# UNITED STATES PATENT AND TRADEMARK OFFICE

| APPLICATION NO. | FILING DATE | FIRST NAMED INVENTOR | ATTORNEY DOCKET NO. | CONFIRMATION NO. |
|-----------------|-------------|----------------------|---------------------|------------------|
| 10/092,767      | 03/07/2002  | Dieter Kress         | 2146.GLE.PT         | 8734             |

## Office Action Summary

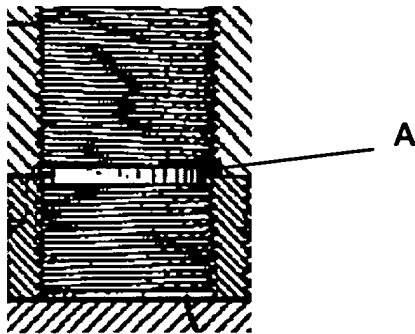
As to claim 6, Sanderson discloses a device for connecting two tool parts **1,2,4** configured for receiving a threaded spindle, each of the tool parts having an associated threaded area, and wherein the device comprises:

a threaded spindle **3** having a projecting shoulder **7**, the outside diameter of which is slightly smaller than the interior diameter of the associated threaded area of one of the tool parts **1** to approximate the interior diameter such that the projecting shoulder serves to guide the threaded spindle into, and provide axial and angular alignment between, the two tool parts, the projecting shoulder having a centered (co-

centrically centered with the axis of spindle 3) and axially inwardly extending opening 10 configured to receive a tool for effecting rotation of the threaded spindle when the projecting shoulder is inserted within a tool part (Figures 1 and 7).

As to claim 7, Sanderson discloses a device wherein a threaded spindle 3 has a first end 7 and a second end A and further comprises a projecting shoulder 7,A at each said end (Figure 1 reprinted with annotations below).

As to claim 8, Sanderson discloses a device wherein the outside diameter of a projecting shoulder 7,A at each end 7,A is slightly smaller than the interior threads of an associated threaded area of a corresponding tool part 1,2,4 to approximate the interior threads thereof to guide a threaded spindle 3 into, and provide axial and angular alignment between, the two tool parts (Figure 1).

As to claim 9, Sanderson discloses a device wherein a threaded spindle 3 has two threaded sections 5,6, each being threaded in a direction opposite the other and assigned to corresponding threaded areas of tool parts 1,2,4 (Figure 1).

a threaded spindle **3** having a first threaded sections **5** for engaging the threaded area of the first tool piece and a second threaded section **6** for engaging the threaded area of the second tool piece, and wherein the threaded spindle has a shoulder **7** extending beyond one of the threaded sections, the projecting shoulder having an outer diameter slightly smaller than the interior diameter of the threaded area of the first tool piece for approximating the interior diameter of the threaded area to thereby guide the threaded section into the threaded area and provide axial and angular alignment of the first and second tool pieces, the projecting shoulder having a centered (co-centrally centered with the axis of spindle **3**) and axially inwardly extending opening **10** configured for receiving a tool for effecting rotation of the threaded spindle via the projecting shoulder when inserted in the first or second tool piece (Figures 1 and 7).

As to claim 13, Sanderson discloses a connection wherein a second tool piece **2,4** partially nests within a first tool piece **1** (Figure 1).

As to claim 14, Sanderson discloses a connection wherein a threaded spindle **3** has a opposing ends **7,A** and has a projecting shoulder **7,A** at each end (Figure 1).

As to claim 15, Sanderson discloses a connection wherein the outside diameter of each projecting shoulder **7,A** at each end **7,A** is slightly smaller than the interior threads of an associated threaded area of a corresponding tool piece **1,2,4** to

approximate the interior threads to guide a threaded spindle 3 into place and to provide axial and angular alignment between first and second tool pieces 1,2,4 (Figure 1).

As to claim 16, Sanderson discloses a connection wherein threaded sections 5,6 of a threaded spindle 3 have opposing orientations and are assigned to corresponding threaded areas of tool pieces 1,2,4 (Figure 1).

Examiner disagrees. As to claims 6 and 12, Sanderson discloses a device comprising a threaded spindle **3** having a projecting shoulder **7** having a centered (co-centrally centered with the axis of spindle **3**) and axially inwardly extending opening **10** configured to receive a tool for effecting rotation of the threaded spindle when the projecting shoulder is inserted within a tool part (Figure 1).
